SERVICE CAMPAIGN BULLETIN

CAMPAIGN REF: 02U
TITLE : Park Distance Control Module Replacement
DOCUMENT # : 11 A 052
AFFECTED VEHICLES : McLaren 650S Coupe and Spider

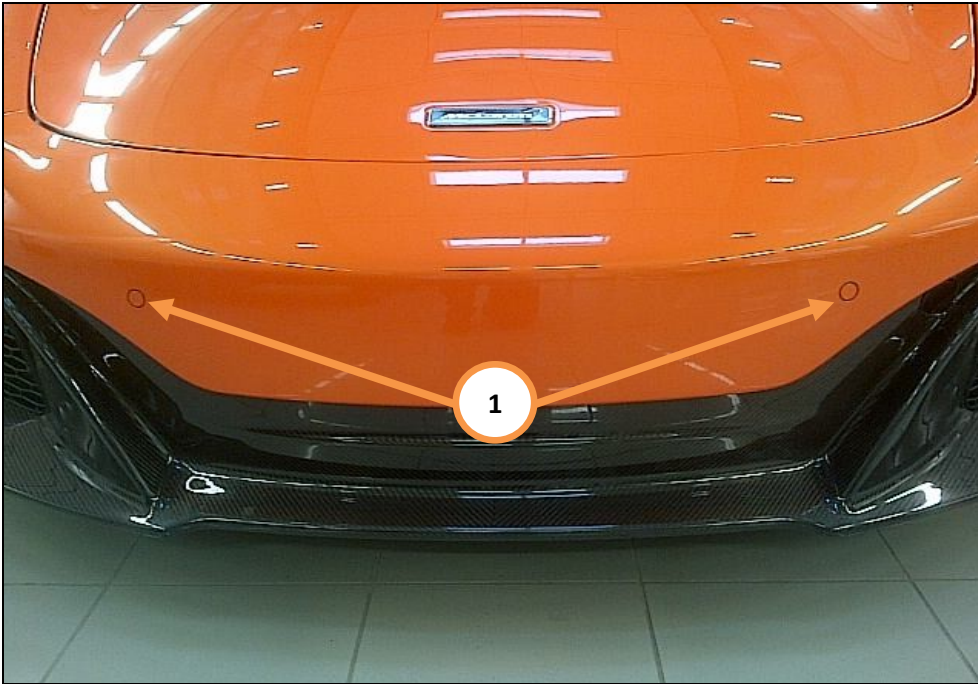
11. Proceed and remove the installed heli-tape disc to the two front centre parking sensors (1).
